From: Williams, Jeffrey
Sent: Monday, June 15, 2020 8:18 AM
To: 'Cindy Cooper'
Cc: Bernard, Dana; Benjamin Cooper (Isaiah)
Subject: RE: 7201 Pindell School Rd

Program Supervisor, Well & Septic Program

Howard County Health Dept.

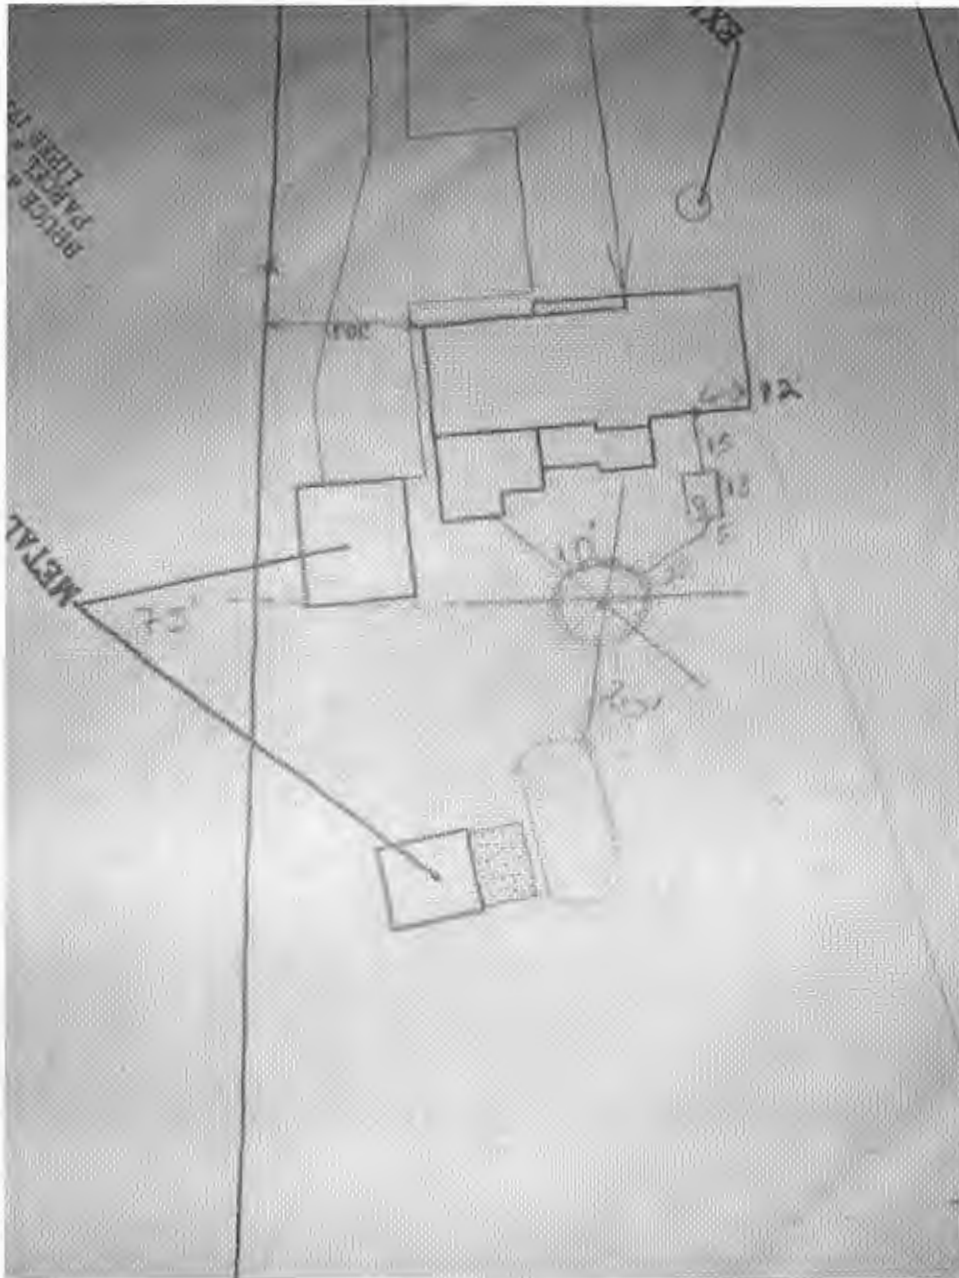
This process has caused us to dig and find the exact location of our septic tank which we needed to do. Following the info on the diagram of the 1966 document, we were able to mark out and locate the drywell. We also learned of the discrepancy on where the septic tank was placed on the survey, which we commissioned in 2017.

After digging the septic tank and then measuring out the line to the drywell (see picture with black lines), we also measured a 10' circumference (see picture with orange hand drawn circle).

From this, we measured 4 points, each at 20 feet away from the border of the circumference and identified one that would allow us to site the pool 20' feet away. Please see attached pic survey portion with correct site of septic tank, line, and drywell, and proposed site for pool in pencil. The pencil drawing is at a 50' scale. This location will likely require us to break up and remove the concrete patio in front of the shed.

Please let me know if this site location us acceptable for safety.

I think this pool location looks fine. Just to verify, your plan shows the proposed pool 20' from the close edge of the drywell perimeter, not the center of the drywell? I can accept this location with a waiver approval to not establish future repair area at this time and with your written acknowledgement in your waiver request that if that area is needed for future repair area, you will relocate the pool. I'm hopeful that future repair area can be located toward the other side of the rear yard away from the sheds, so it should still leave plenty of room.

Just submit a hard copy of this new plot plan and email me when you do so. We can approve the permit once we see that plan. Thanks
Jeff
